SITE PLAN

MADISON TOWNSHIP, LAKE COUNTY, OHIO

for: NORTHCOAST HOMES
CLIENT OWNER

DRAWN BY HT	SCALE 1" = 30'	PHONE NO. 357-1811	
CHK'D. HT	DATE 1/29/97	DRAWING NO. 96-311-B	
CREW CHIEF KJ	APP'D. HT

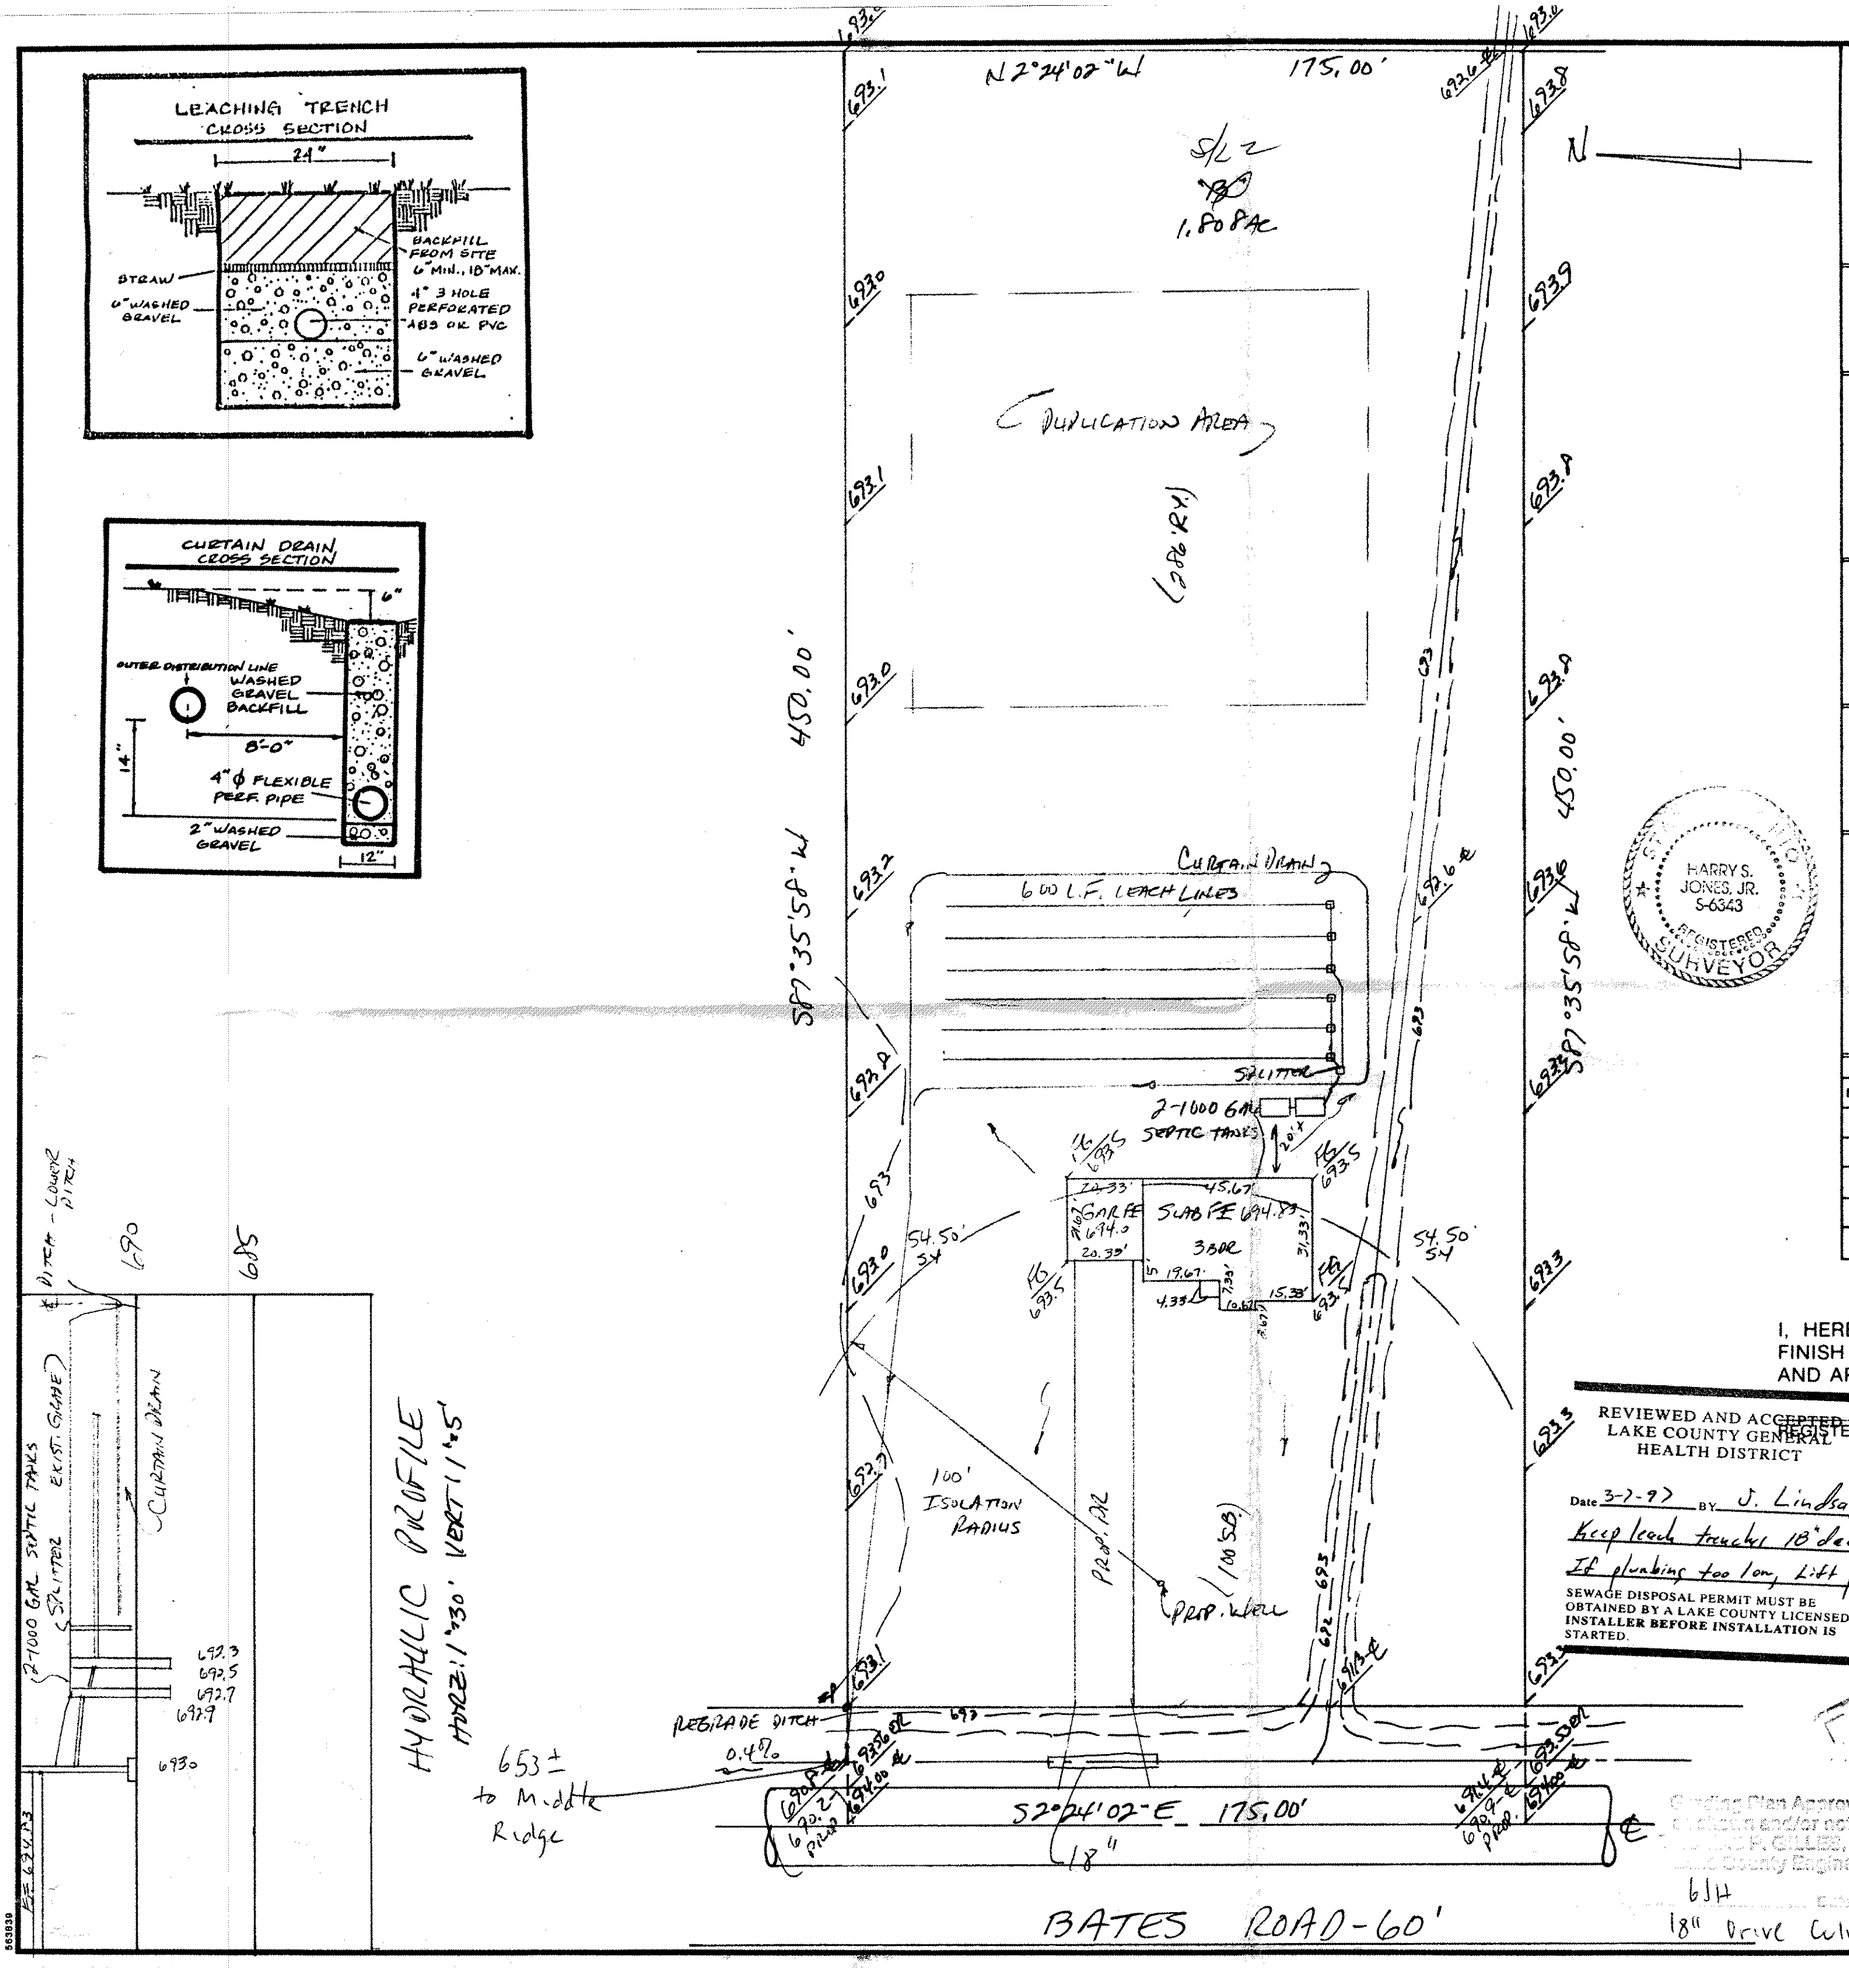
Date 3-7-97 BY J. Lindsay TBM – ℄ PAVEMENT @ N.W. CORNER OF THIS PARCEL ELEV. = 694.00
Keep leach trenches 18" deep
If plumbing too low, Lift pump may be needed

Grading Plan Approved
as shown and/or noted
Lake County Engineer
6/H 4-2-97
18" Drive Culvert
